RCO - Request for Change

Middletown Senior/Community Center Sept. 30, 2014

RCO # 033

Description: Kiln transformer

SK
E-3

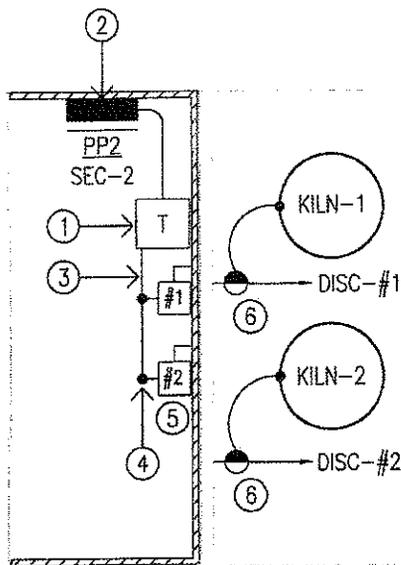
The following is our cost to furnish and install a new kiln room transformer as detailed in SK-E3.

- ① PROPOSED LOCATION FOR BUCK & BOOST TRANSFORMER RATED FOR 25KVA, 120/208V-240V. COORDINATE MOUNTING LOCATION IN THE FIELD AND PROVIDE ALL COMPONENTS NECESSARY FOR A COMPLETE MANUFACTURER APPROVED INSTALLATION, INCLUDING GROUND TO BUILDING STEEL.

- ② PROVIDE 150A-2P C/B, 1-1/2"C, 3#1/0, 1#8G TO SUIT BOOST TRANSFORMER PRIMARY CONNECTION.
- ③ PROVIDE: 3#2, 1#8G IN RACEWAY. CONTRACTOR SHALL TAP FEEDER WITHIN RACEWAY TO SUIT DISCONNECT/ENCLOSURE BREAKER. TAP FEEDER AS PER NEC-2011 REQUIREMENTS. PROVIDE ALL COMPONENTS NECESSARY FOR A COMPLETE NEC-2011 APPROVED INSTALLATION.

- ④ PROVIDE: 1"C, 3#6, 1#10G TO SUIT DISCONNECT/ENCLOSURE BREAKER.
- ⑤ PROVIDE 60A-2P FUSED DISCONNECT SWITCH OR ENCLOSED CIRCUIT BREAKER. COORDINATE MOUNTING LOCATION IN THE FIELD AND CLEARANCE AS PER NEC REQUIREMENTS. TYPICAL OF 2.

- ⑥ DEDICATED NEMA RECEPTACLE TO SUIT KILN UNIT RATED FOR 240V. COORDINATE CONNECTION REQUIREMENT WITH EXISTING EQUIPMENT IN THE FIELD.

Install buck Boost Transformer and feeder for the new Liln in Room 216
 and as per drawinf SK-E3.
 the Buck Boost transformer will by 5 KVA and good for 135 anps.
